# APPEAL OF THE PLANNING COMMISSION'S APPROVAL OF THE VISTA DEL MAR PROJECT

## The Vista Del Mar Project

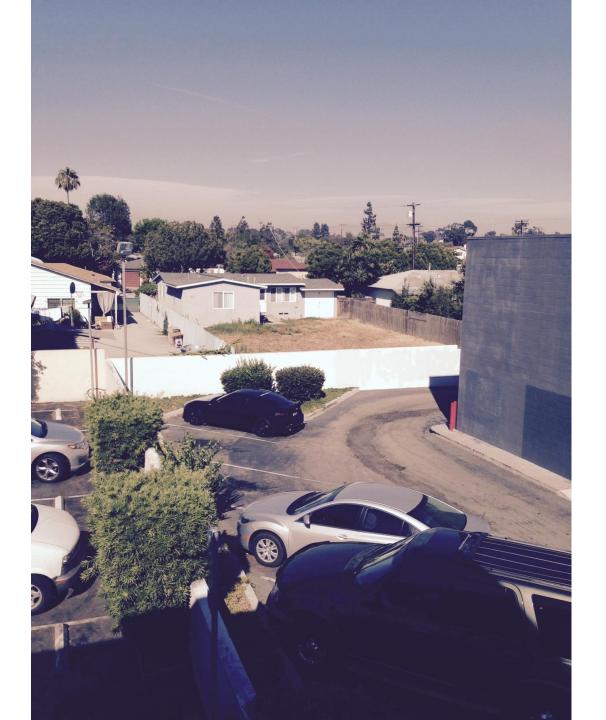
- Approval of a Development Exception requires four findings to be made
- One finding is that "The proposed development will comply with all other regulations of the Specific Plan."
- Planning Commission erred in finding that the Vista Del Mar Project complied with all other regulations of the UCSP
  - NTCD Regulations include:
    - "Building design shall be cognizant of adjacent low density uses (*i.e.*, avoid balconies overlooking rear yards.)"

#### Staff asserts that the intent of the provision directing that balconies be avoided if they overlook rear yards "is not to do away with balconies but rather to address their potential effects on privacy."

- No legislative history to support this
- Staff points to policies and guidelines in the UCSP and General Plan which "<u>encourage</u> the use of balconies" and states that those guidelines must be read "in harmony" with the <u>requirement</u> in the NTCD regulations to avoid balconies if they overlook rear yards of single-family homes

- Even if staff were correct that the intent of the NTCD requirement to avoid balconies if they would overlook the homes and yards of single-family homes is merely to "address their potential impacts on privacy" – the Vista del Mar Project fails to address those privacy concerns in a satisfactory way
- Staff touts that the Project meets the minimum step-down requirements of the C-1 NTCD and that the structure has been distanced "as much as possible" from the single family residences
- But the distancing is minimal, as stated in the staff report to the Planning Commission:
  - "The second floor terrace is approximately <u>**13 feet**</u> from the property line"
  - "The balconies along the east building elevation are approximately <u>47 feet</u> from the property line...."

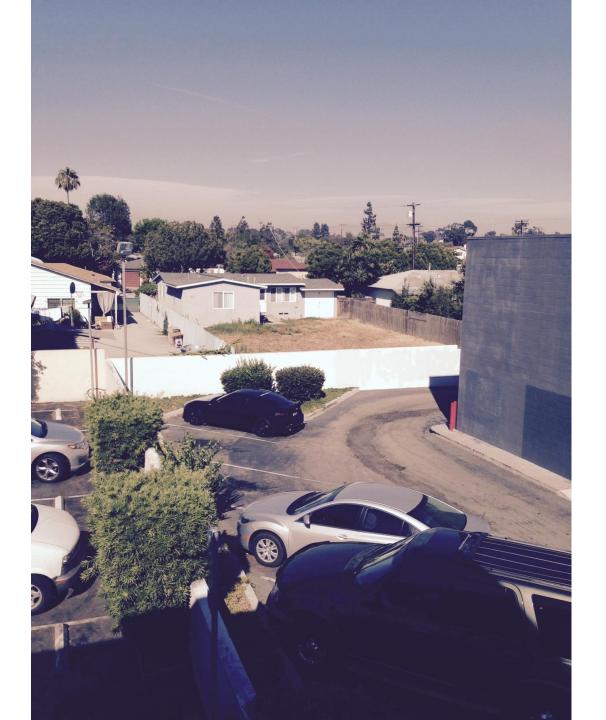
Staff claims that planting of trees and shrubs in containers along the perimeter of the second floor terrace will protect the privacy of the residents in the adjacent single-family homes

- Wrong, because those plantings will not create a continuous wall of greenery that will prevent the residents of the 71 units and their guests from looking between the shrubs and trees into the yards of their singlefamily neighbors
- Those plantings will simply shield the residents of the 71 units from the views of those in the homes and yards down below
